SECTION 4.55 (2) MODIFICATION

Development Application No.	MODDA046/23 & (PAN- 395136) DA228/15
Subject Site	Lot 1 DP1249852, 38 Maple Crescent Lithgow 2790
Proposal	<p>Demolition and Construction of Residential Aged Care Facility (Lithgow Aged Care)</p> <p><u>Proposed Modification:</u></p> <ul style="list-style-type: none"> • Reduce total beds from 144 to 132 new beds (including already constructed Building A) and reduce total beds from 213 to 178 beds • Reconfiguration of 3 new buildings (B, C & D) still to be constructed (Building A completed) • Demolition of previously retained Madden & Gillard houses prior to construction of Building D • Three (3) stages of development • Ancillary works <ul style="list-style-type: none"> ○ changes to internal configurations of buildings ○ earthworks ○ stormwater & utilities ○ carpark configurations and sizes changed
Zoning	R1 General Residential
Applicant	Respect Group Ltd
Owner	Respect Group Limited

Executive Summary

Figure 3 - Proposed Site Layout (MODDA046/23)

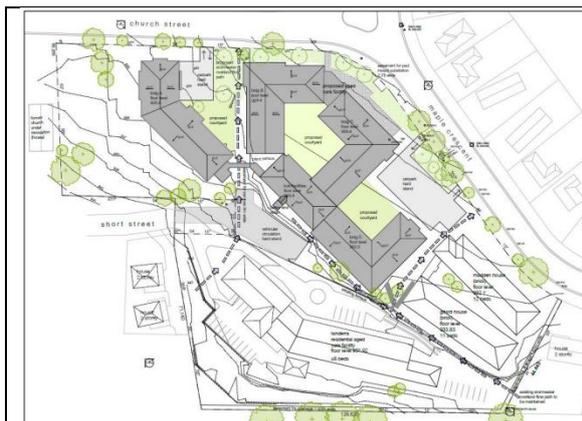
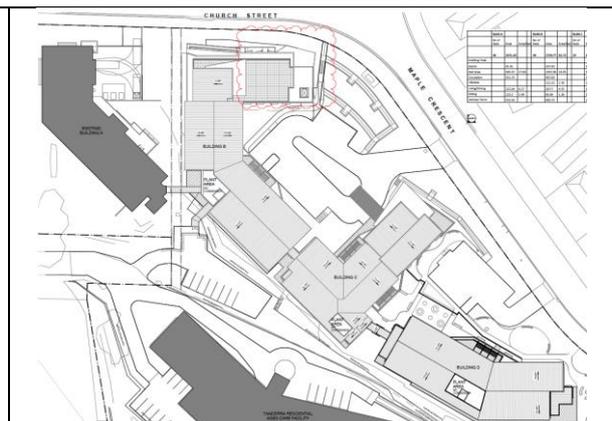
A comparison of the approved site plan and proposed site plan is provided below (also see the separate Architectural Plans):

The original scheme retained the Madden/Gillard/Tanderra buildings but this resulted in a much denser development of new buildings over Coinda/Coates House with an internal courtyard and reduced views. The proposal will replace Madden/Gillard Houses and spread the four (4) buildings over a larger area to reduce density, increase building separations, improve views for residents, increase landscape spaces, and upgrade the facilities.

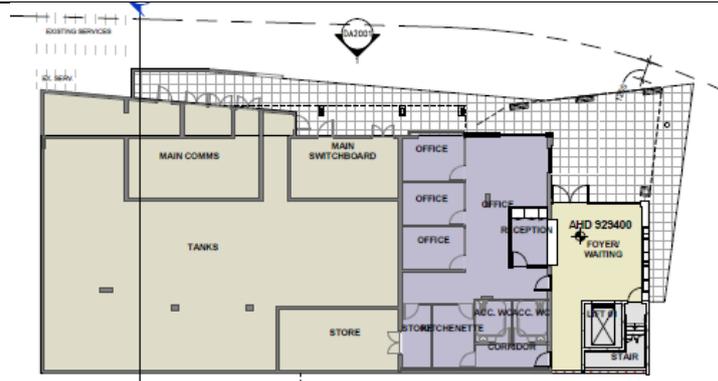
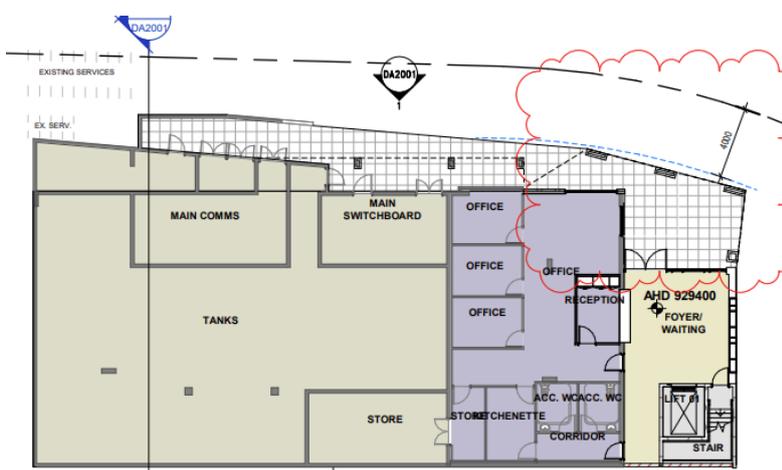
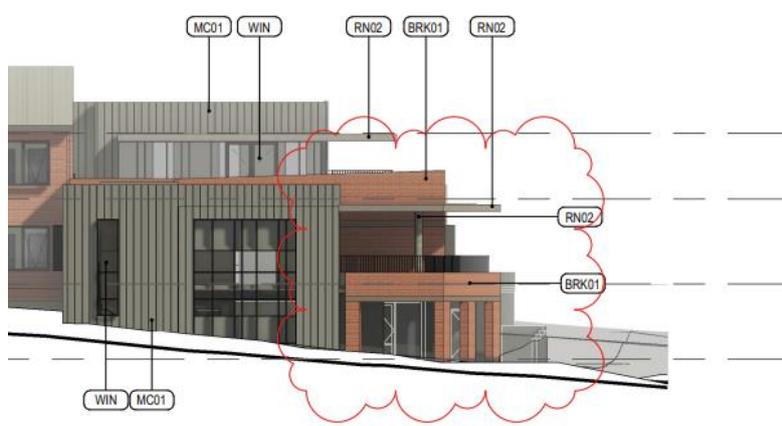
Concern	Council Comment
The building design for Building B provides a setback that is concerning at 1.2m and design is stark & unsightly.	<p>The design has been amended to change this area to increase the setback to 4m and change the roofline as shown in below images:</p> <p>Original Design:</p>

These amended designs have addressed the issue of setbacks and design accordingly and is acceptable by Council.
